The purpose of this letter is to confirm that the proposed grading and drainage improvements associated with the above referenced property is in conformance with the “Final Drainage Report for Parker Pointe Parker, Colorado”, prepared by Perception Design Group Inc., and dated March 2020. (PDG report).

HUNTINGTON NATIONAL BANK
LOT 3A: PARKER POINT SUBDIVISION FILING NO. 1, AMENDMENT NO. 1, LOCATED IN THE NORTHEAST 1/4 OF SECTION 3, TOWNSHIP 6 SOUTH, RANGE 66 WEST OF THE 6TH P.M., TOWN OF PARKER, COUNTY OF DOUGLAS, STATE OF COLORADO

DRAINAGE MAP

Project: Huntington Parker

EXISTING DRAINAGE PLAN

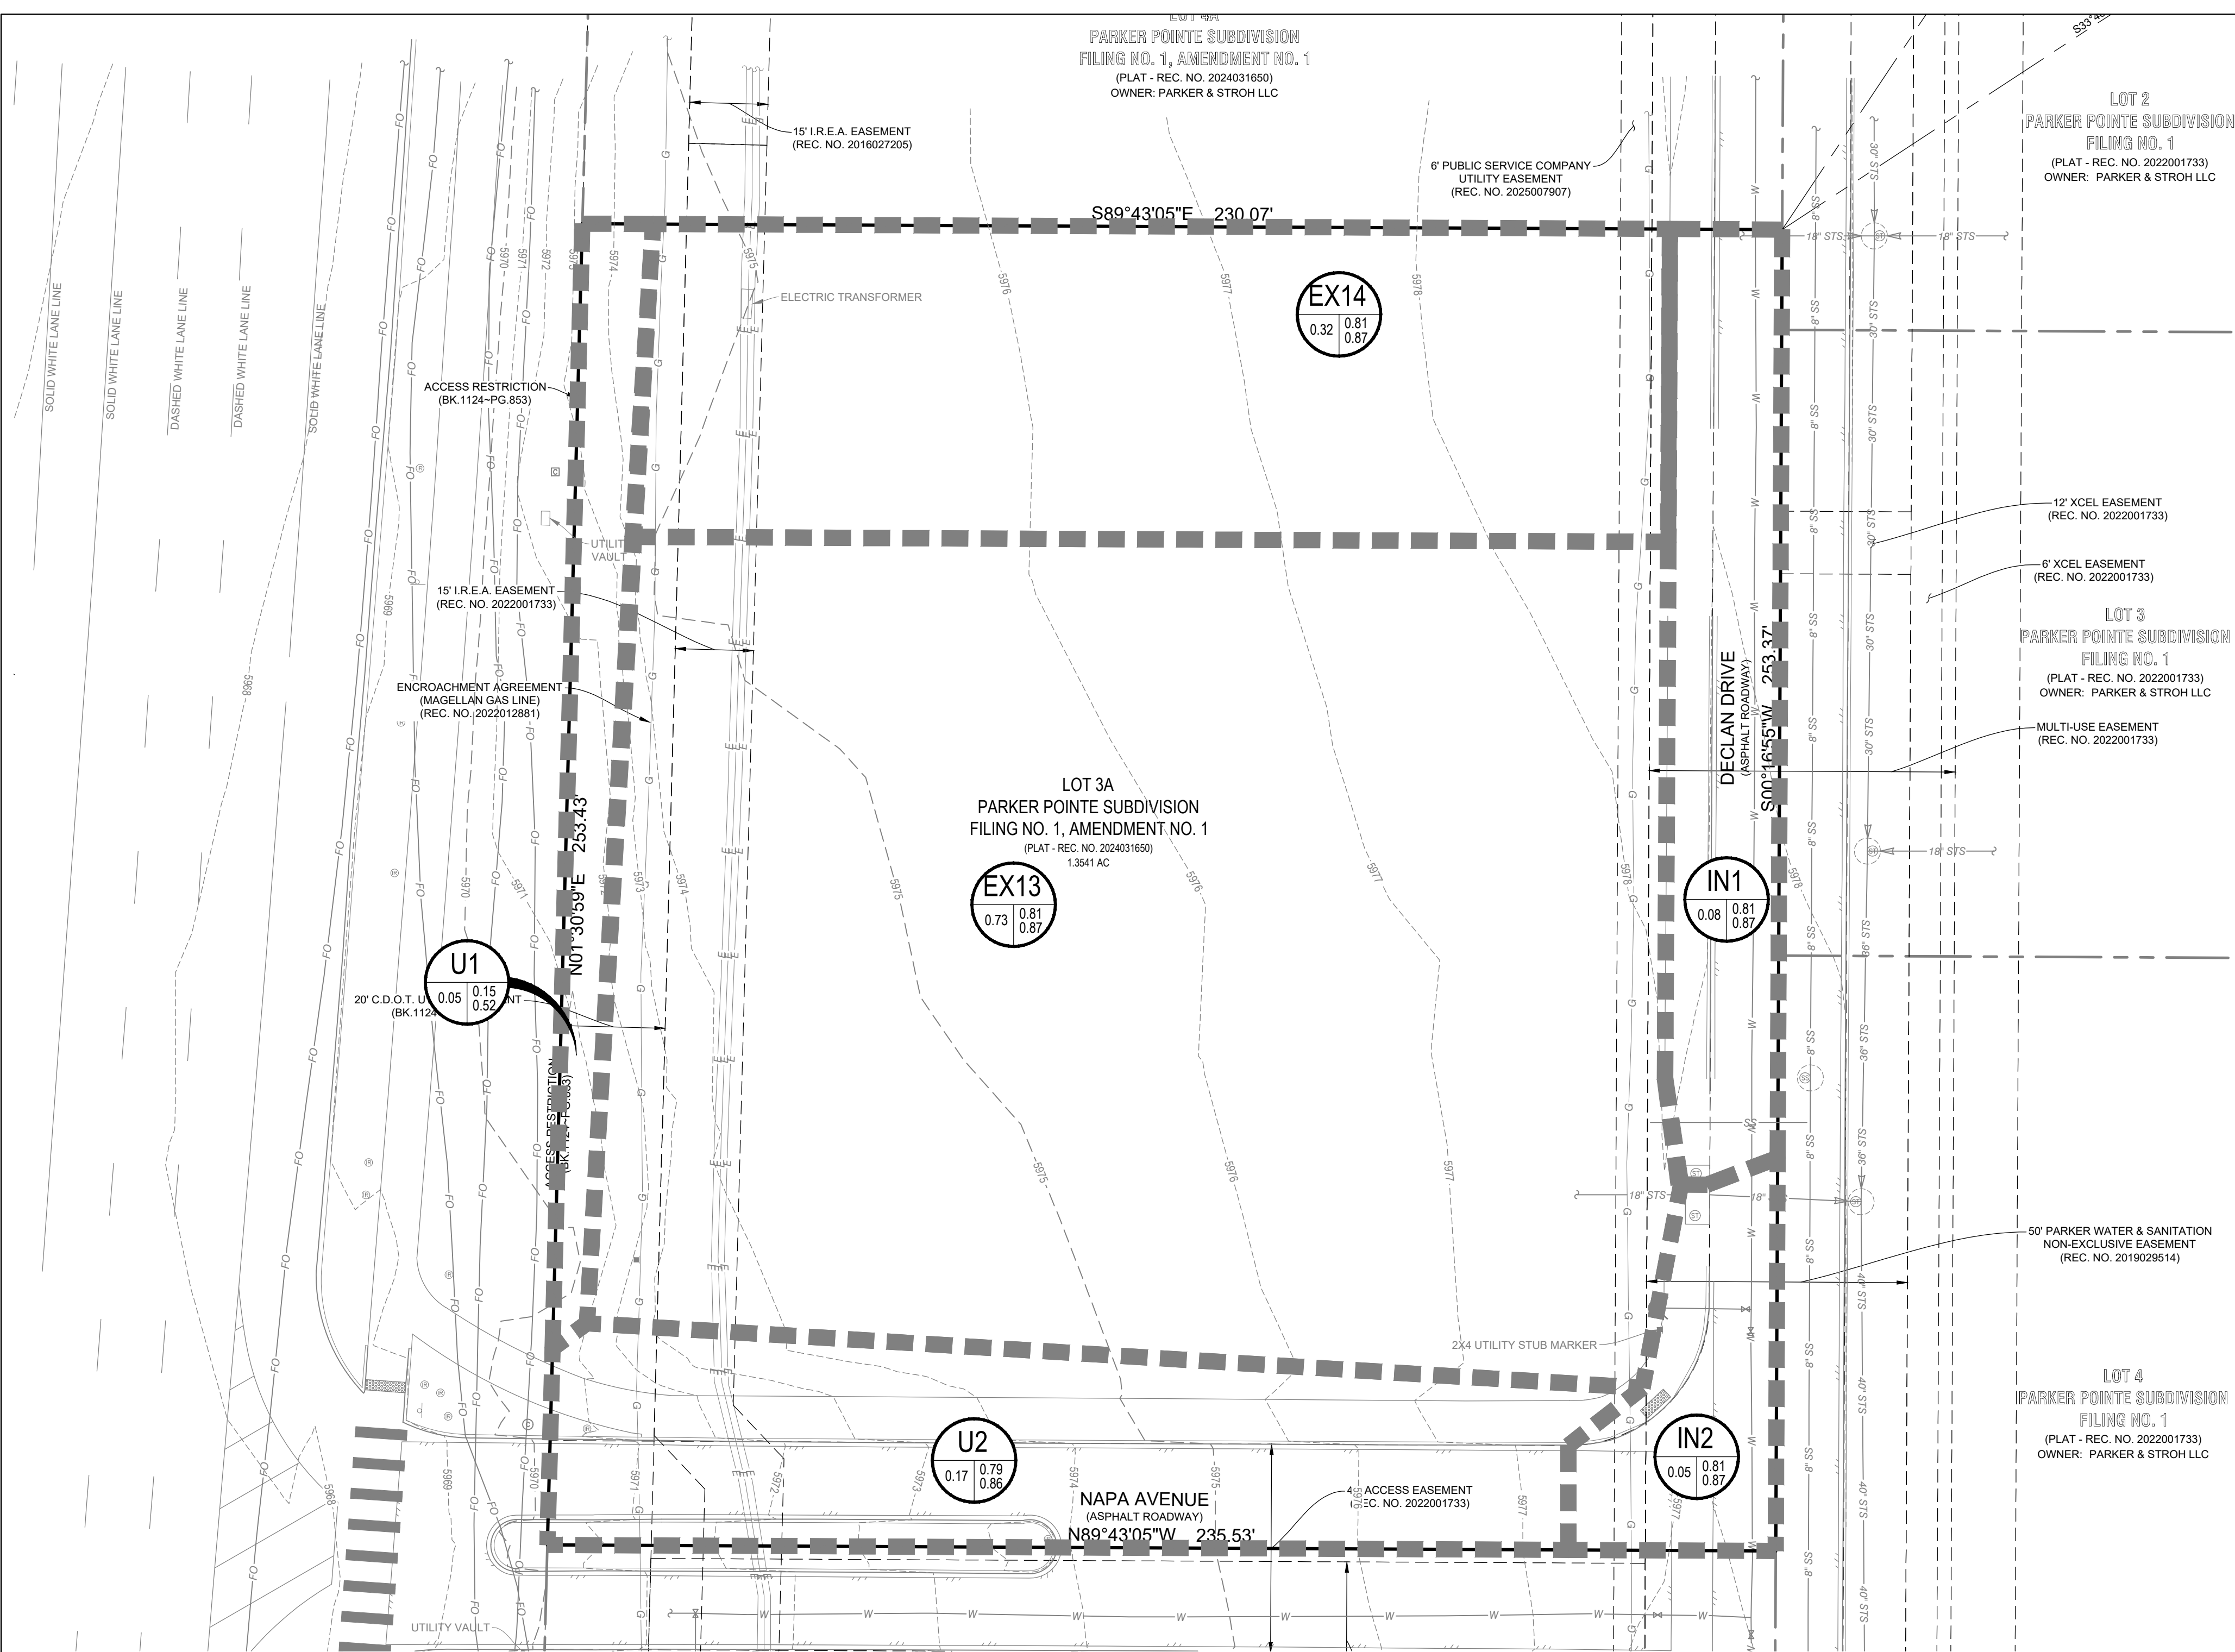
The drainage plan indicates that there are proposed storm runoff flows that are routed offsite and undetained. Please provide discussion that describes what percentage of the overall project site (applicable area of development) is undetained and further describe the percentage of impervious areas that these undetained sub-basins makeup.

The drainage plan indicates that there are proposed storm runoff flows that are routed offsite and undetained. Please see Section 7.2.3 of the SDECM and provide discussion of why all portions of the site are not able to be routed through the proposed detention facility. Compensatory storage will only be permitted in those cases where it is clearly impractical to route all runoff from the developed site through the detention facility.

The proposed undetained flows ultimately outfall from South Parker Road to Kinney Creek to the South. Per Section 8.3.2.3 of the SDECM: If the New Development/Redevelopment discharges to waters-of-the-state then the developer/permittee must, at a minimum, implement on-site PBMPs, such as a grass swale, designed in accordance with this SDECM and the MANUAL Volume 3.

Please describe how the undetained basins are treated (such as grass buffer areas) and provide any supporting calculations.

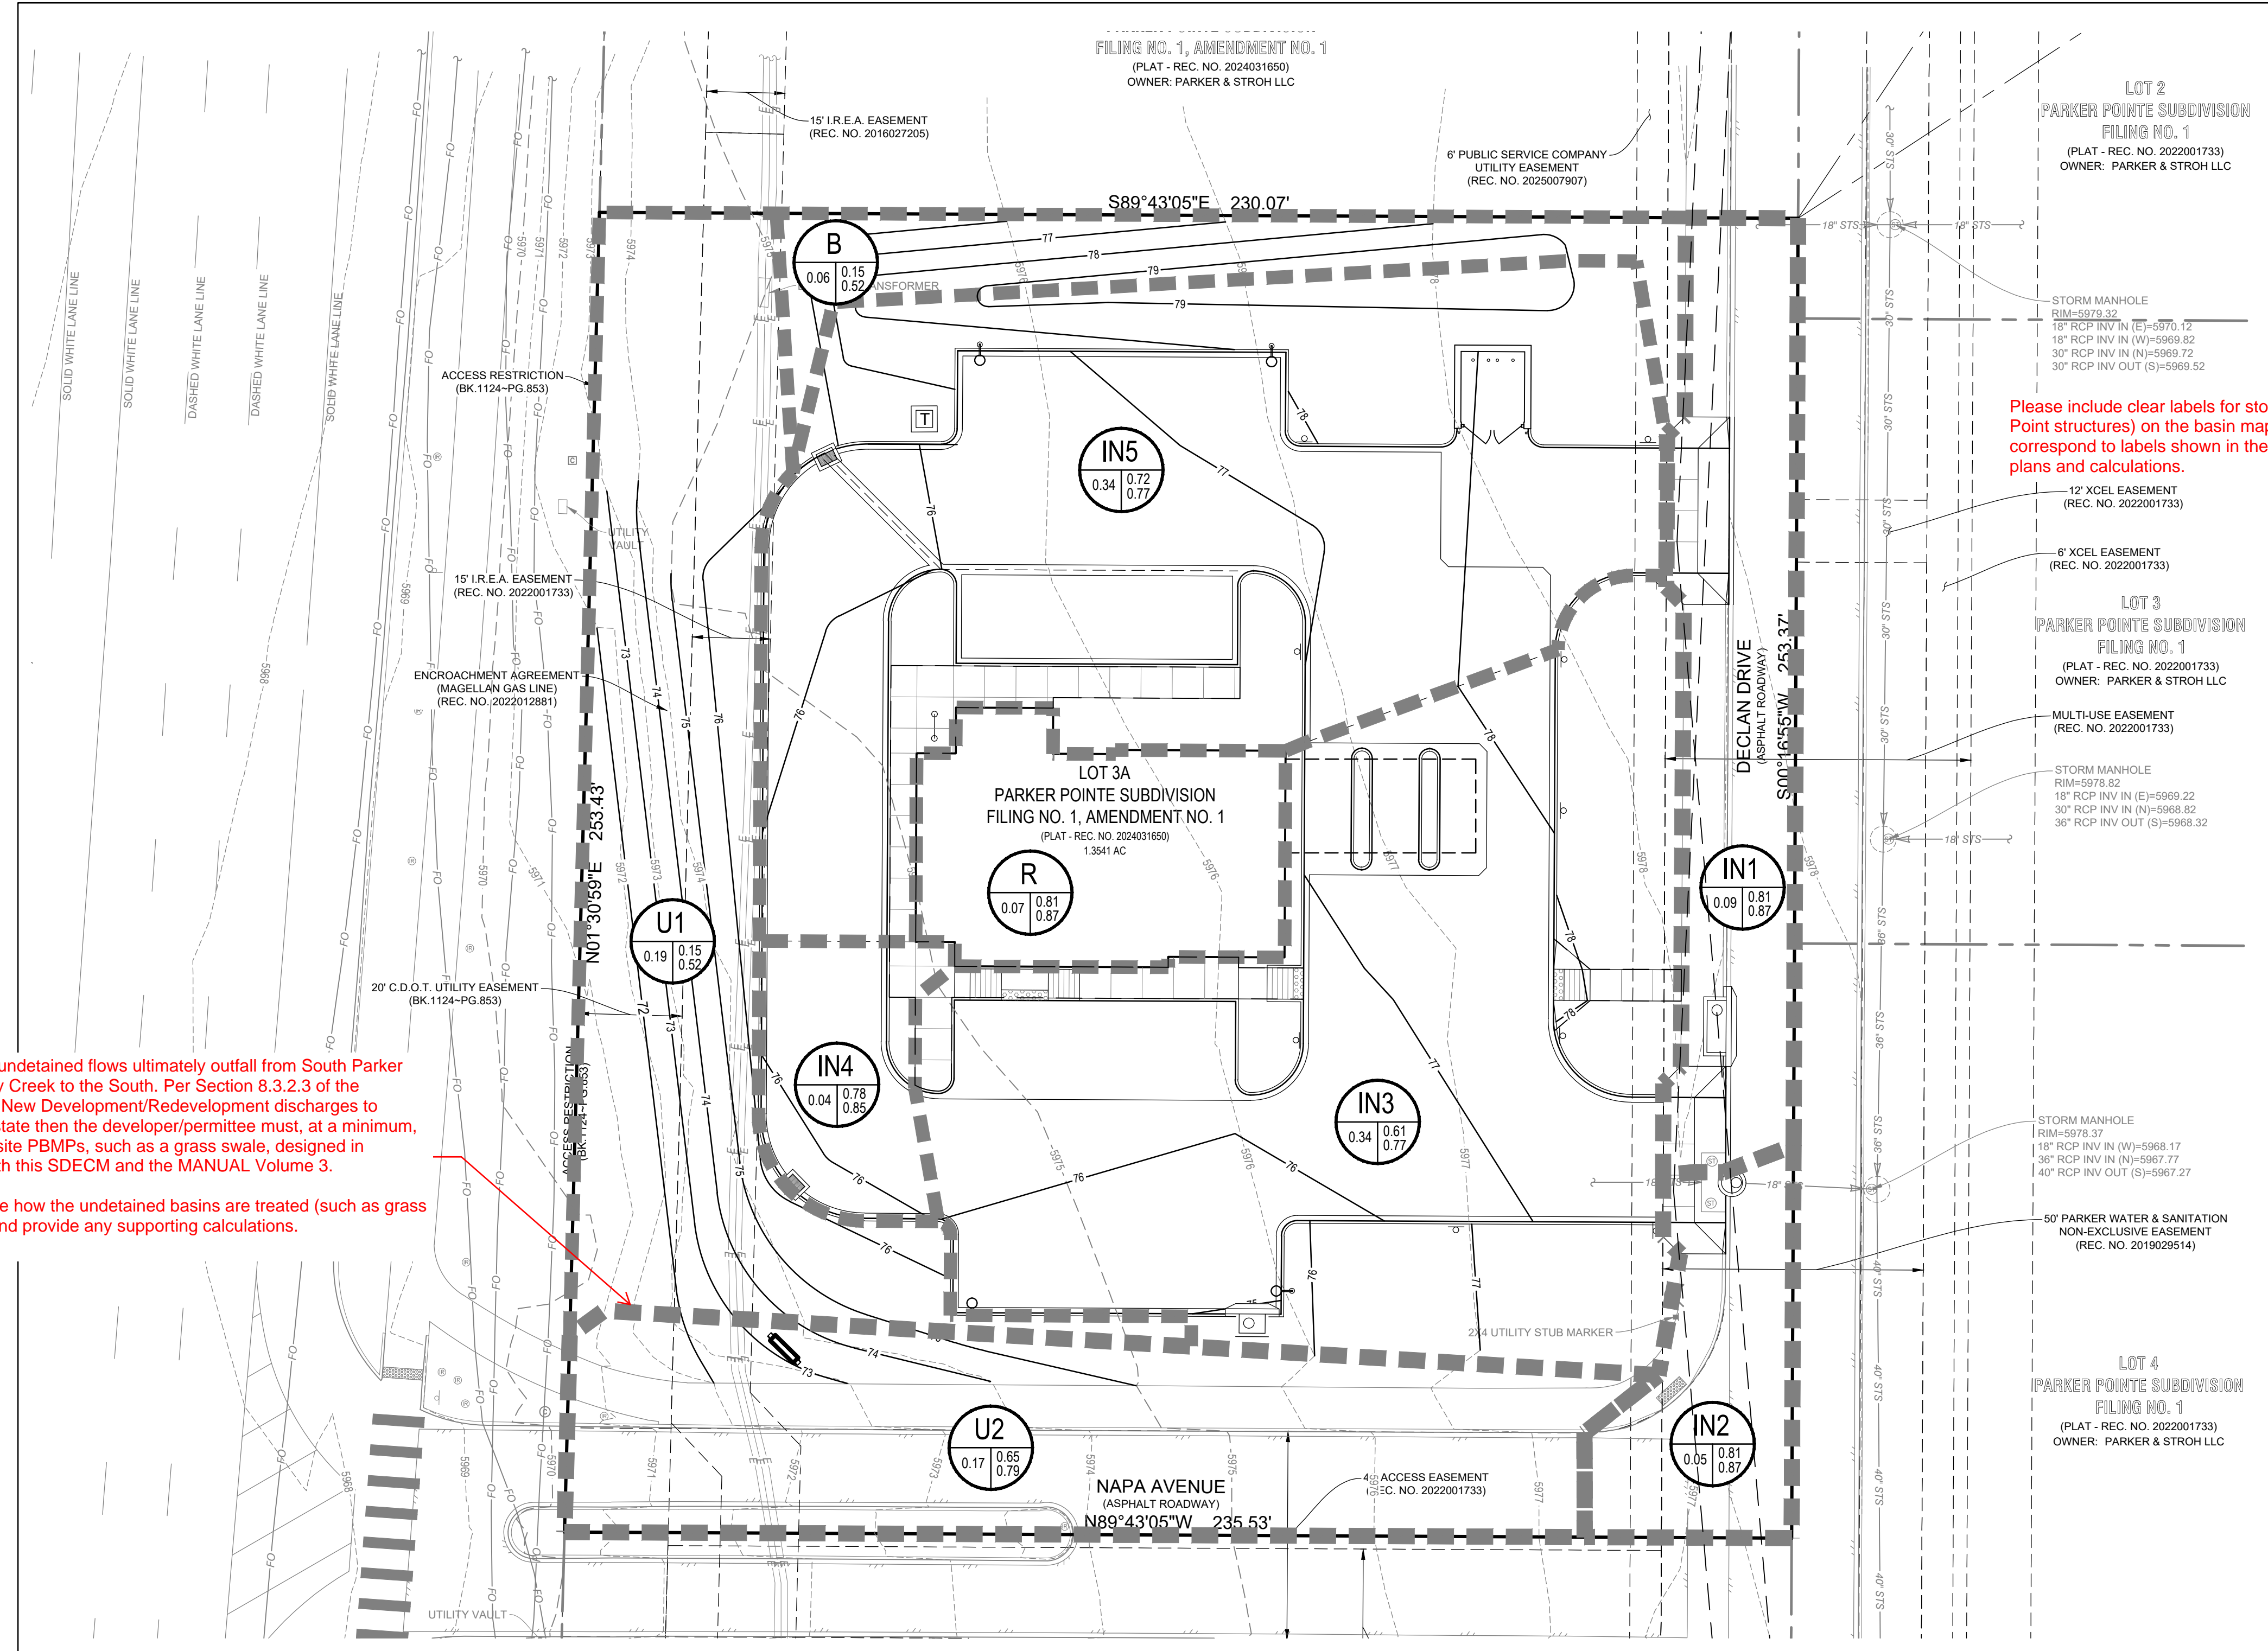
Please include clear labels for storm inlets (Design Point structures) on the basin map that correspond to labels shown in the construction plans and calculations.

The proposed undetained flows ultimately outfall from South Parker Road to Kinney Creek to the South. Per Section 8.3.2.3 of the SDECM: If the New Development/Redevelopment discharges to waters-of-the-state then the developer/permittee must, at a minimum, implement on-site PBMPs, such as a grass swale, designed in accordance with this SDECM and the MANUAL Volume 3.

Please describe how the undetained basins are treated (such as grass buffer areas) and provide any supporting calculations.

DRAINAGE PLAN WEST

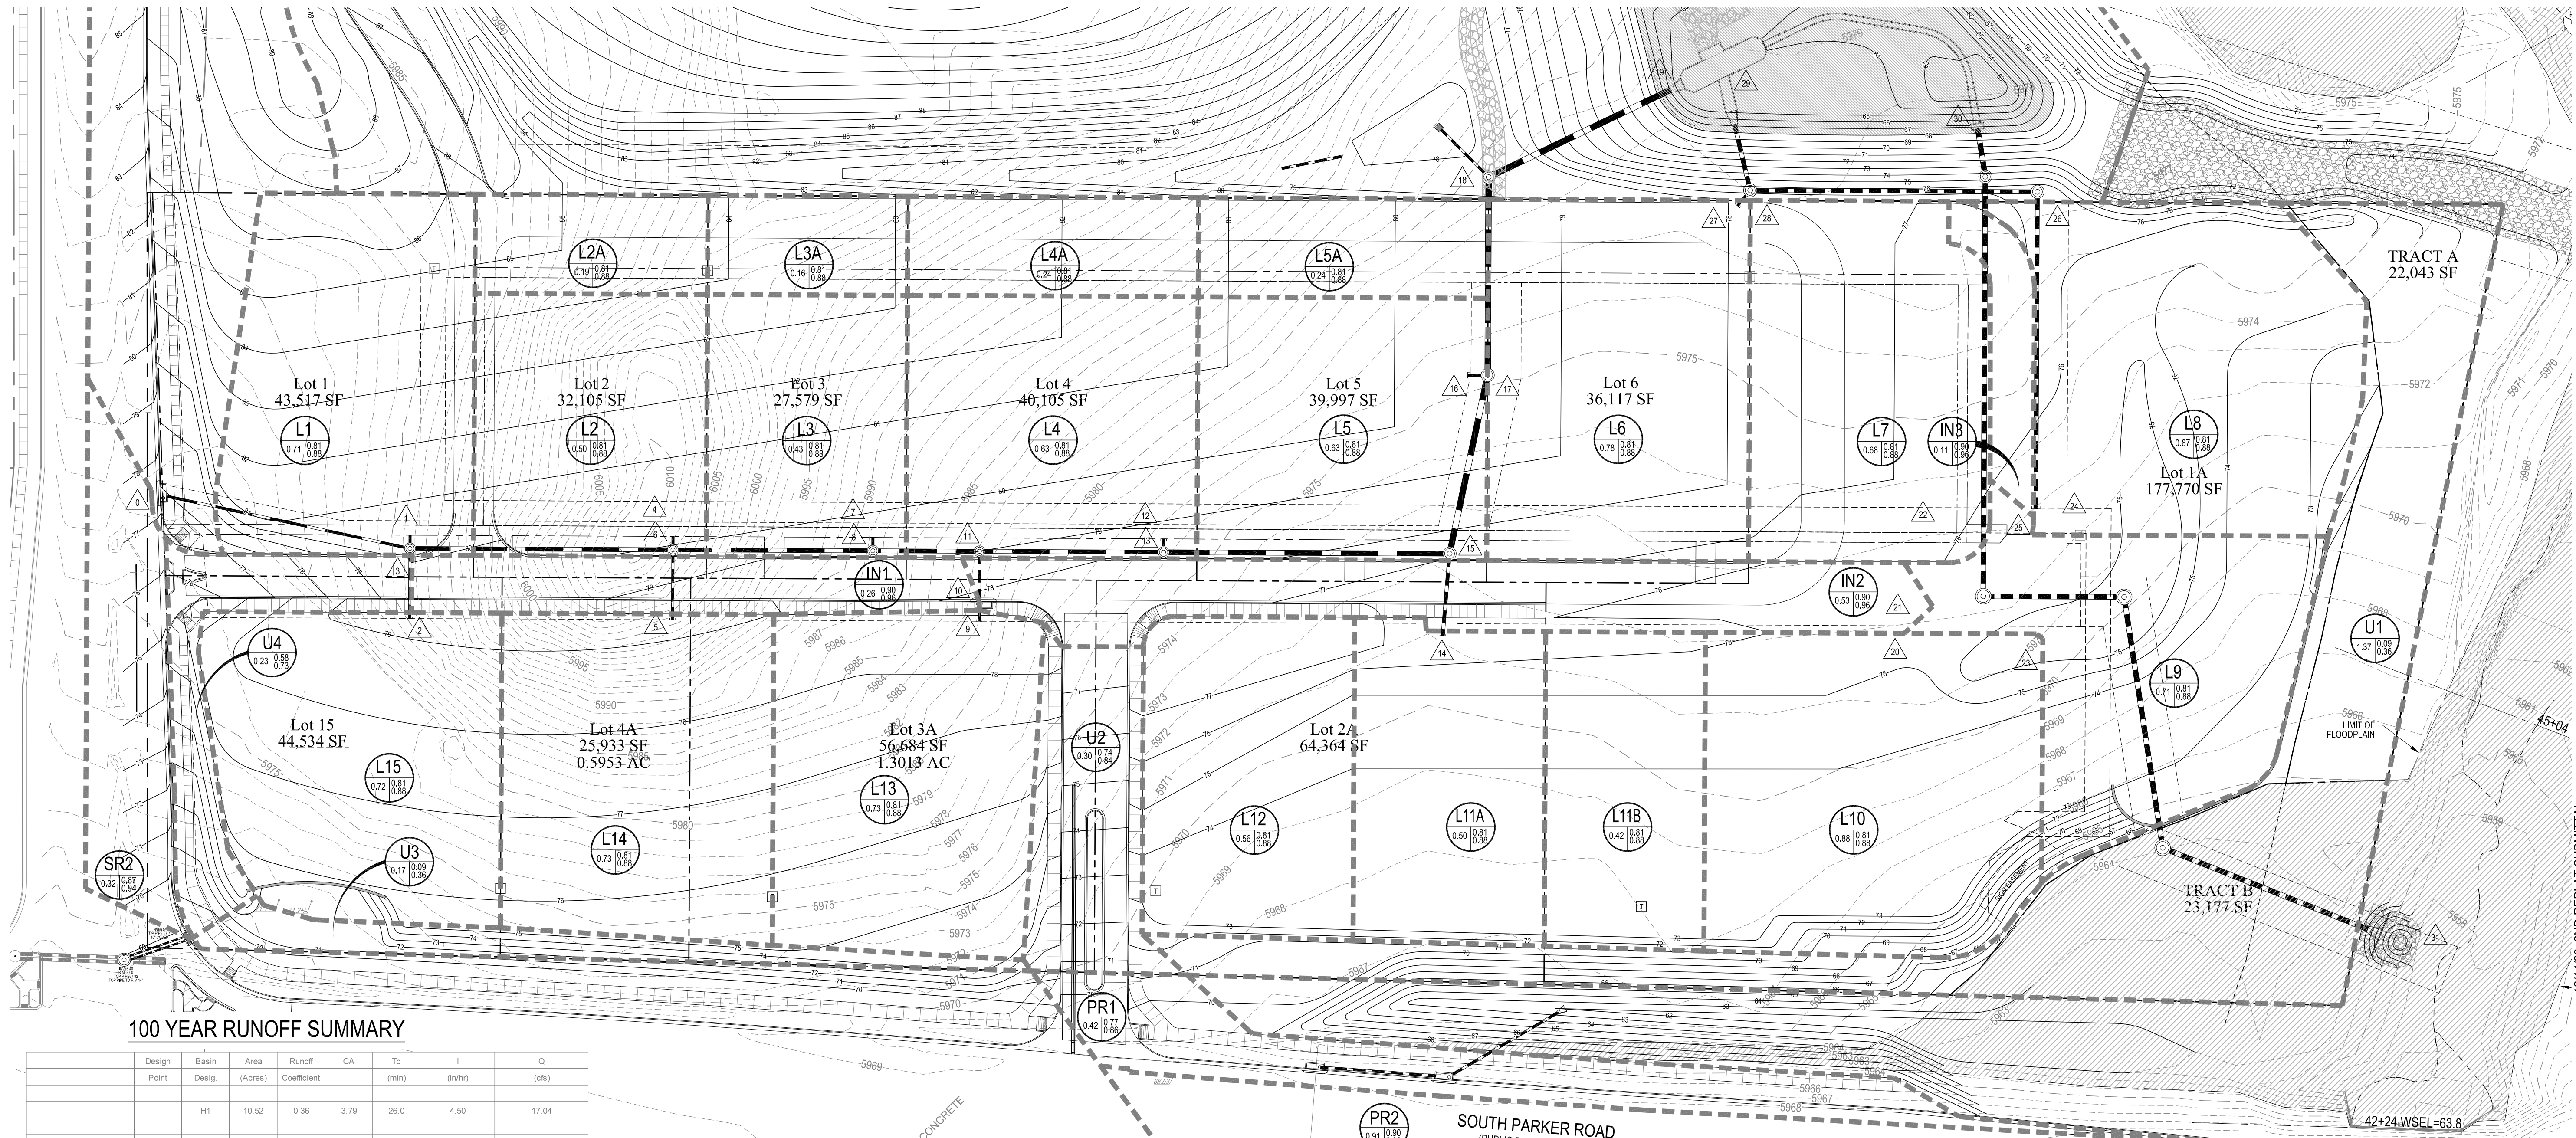
Please include hydraulic calculations for pipe sizing and HGL's for the minor and major storm events. (See Section 6.3.3.4 of the SDECM for Hydraulic Design Requirements)
